**CITY OF MERIDIAN  
FINDINGS OF FACT, CONCLUSIONS OF LAW  
AND  
DECISION & ORDER**

**In the Matter of the Request for Conditional Use Permit for a Drive-Through Establishment for a Financial Institution for KeyBank Meridian Branch within 300-Feet of another Drive-Through Establishment, an Existing Residence and Residential Zoning District, on 1.04-Acres of Land in the C-G Zoning District, by HSB Architects + Engineers.**

**Case No(s). H-2022-0076**

SUBJECT: H-2022-0076  
KeyBank Meridian Branch – CUP

### A. Proposed Site Plan (dated: 4/20/2022)

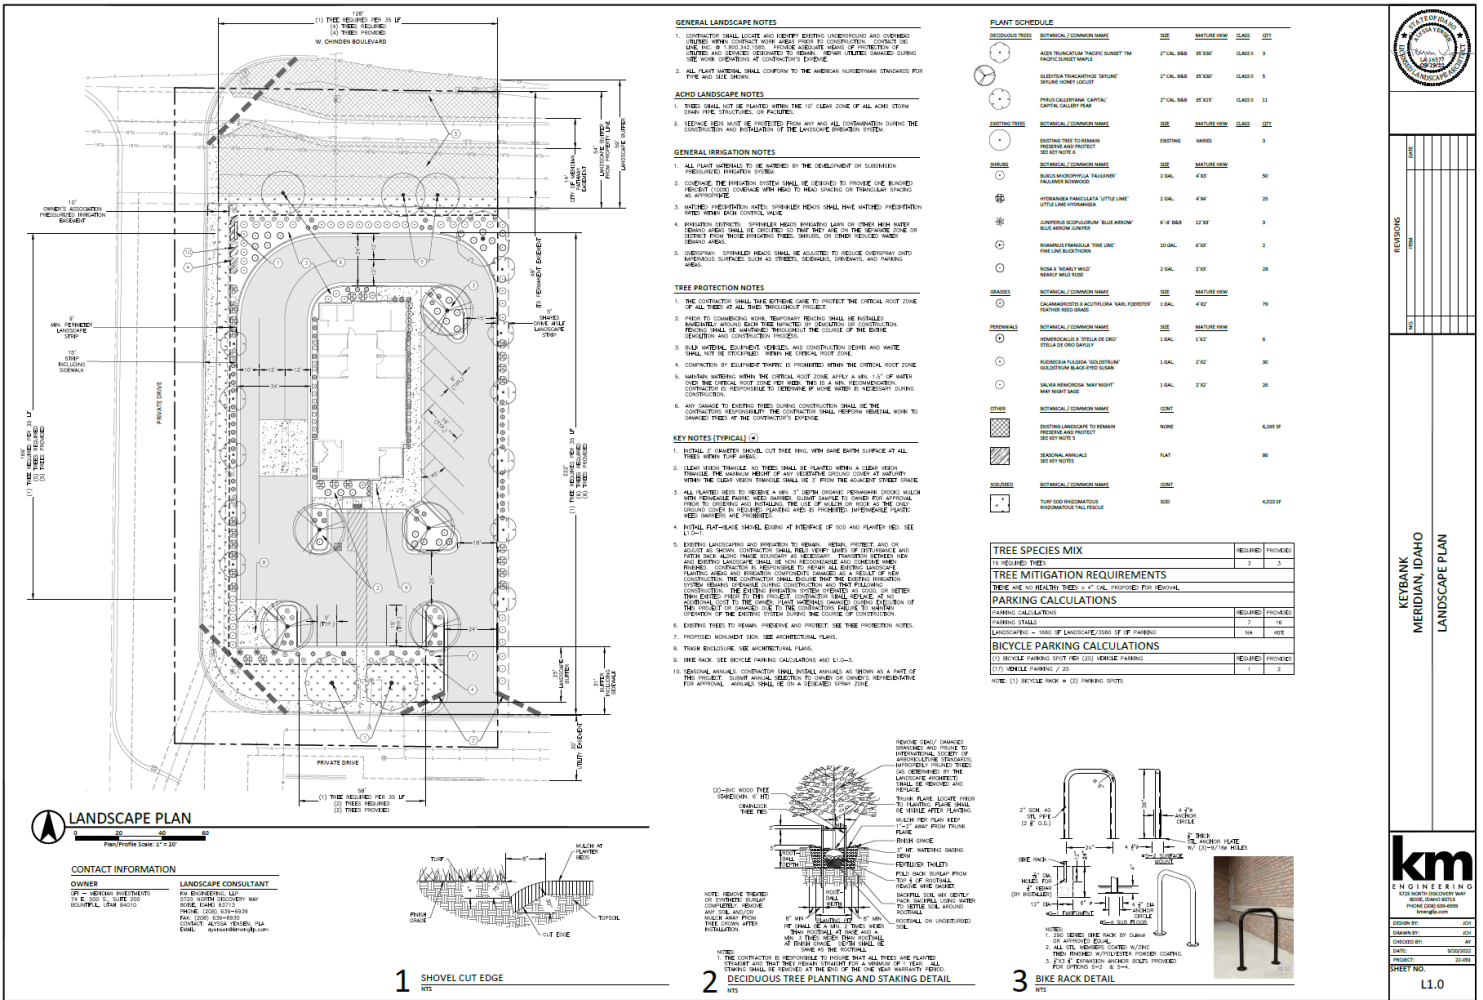
**The site design requires vehicles that are parked on the east side of the building to exit the site through the drive-through escape lane and vehicles accessing the parking spaces on the south side of the building to travel against traffic leaving the drive-through. Staff is concerned about traffic conflicts within the site that may exist because of the site design, as discussed with the applicant in the pre-application meeting. The Applicant did not share Staff's concerns and proceeded with the proposed site layout.**

Parking lot landscaping is required to be provided in accord with the standards listed in UDC [11-3B-8C](#). **A minimum 5-foot wide perimeter buffer is required along the east boundary of the site per UDC 11-3B-8C.1, landscaped per the standards listed in UDC [11-3B-8C.1b](#).** The buffer on the adjacent property to the east does not meet this requirement; remove from the plan.

**Sidewalks:** A 10-foot wide multi-use pathway exists within a public use easement in the street buffer on the northern portion of this site along W. Chinden Blvd. A sidewalk exists within the landscape buffers along the western and southern boundaries of the site along internal driveways within Lost Rapids Subdivision. A pedestrian walkway is proposed from the perimeter sidewalk along the southern boundary of the site to the main building entrance in accord with UDC 11-3A-19.B.4. **Where the walkway crosses the vehicular driving surface, it's required to be distinguished from the vehicular driving surface through the use of pavers, colored or scored concrete, or bricks as set forth in UDC 11-3A-19B.4. The site/landscape plan submitted with the Certificate of Zoning Compliance application should reflect compliance with this standard – the proposed striping on the pathway from the perimeter sidewalk to the main building entrance is not approved.**

**The sidewalk on the south and east sides of the building where parking abuts should be widened to 7-feet to allow vehicles to overhang 2-feet (the length of stalls may be reduced to 17-feet); or, wheel stops should be provided within parking spaces to prevent vehicle overhang in accord with UDC 11-3C-5B.3, 4.**

- b. The pathway from the perimeter sidewalk along the southern boundary of the site to the main building entrance shall be distinguished from the vehicular driving surface through the use of pavers, colored or scored concrete, or bricks as set forth in UDC [11-3A-19B.4b](#).

- f. Widen the sidewalk to 7-feet on the south and east sides of the building where parking abuts to allow vehicles to overhang 2-feet (the length of stalls may be reduced to 17-feet); or, provide wheel stops within parking spaces to prevent vehicle overhang in accord with UDC [11-3C-5B.3, 4](#).

- g. Depict a minimum 5-foot wide perimeter buffer along the east boundary of the site per UDC [11-3B-8C.1](#), landscaped per the standards listed in UDC [11-3B-8C.1b](#); remove the buffer on the adjacent property from the plan.

## B. Proposed Landscape Plan (dated: 9/20/22)

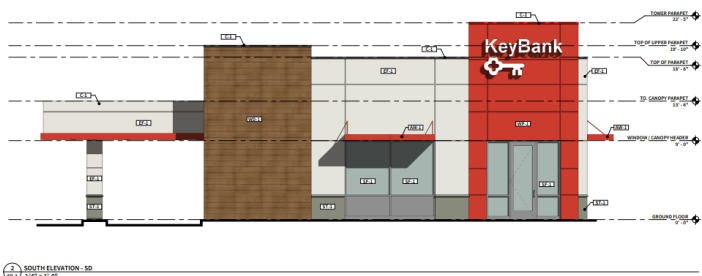
- C. Landscape shrubbery shall be limited to no more than three (3) feet in height between entrances and financial transaction areas and the public street. *The reed grass depicted on the landscape plan in the buffer along the west boundary of the site and the falkner boxwood in the buffer along the northern boundary of the site on the west side of the building has a mature height of 4-feet, which is not allowed; the landscape plan should be revised to comply with this standard.*

- d. Depict shrubbery that is no more than three (3) feet in height at maturity between entrances and financial transaction areas and the public street as set forth in UDC [11-3A-16C](#). *The reed grass within the planter along the west boundary of the site and the falkner boxwood in the buffer along the north boundary of the site exceed 3-feet in height at maturity and should be replaced with shrubbery that meets this standard.*
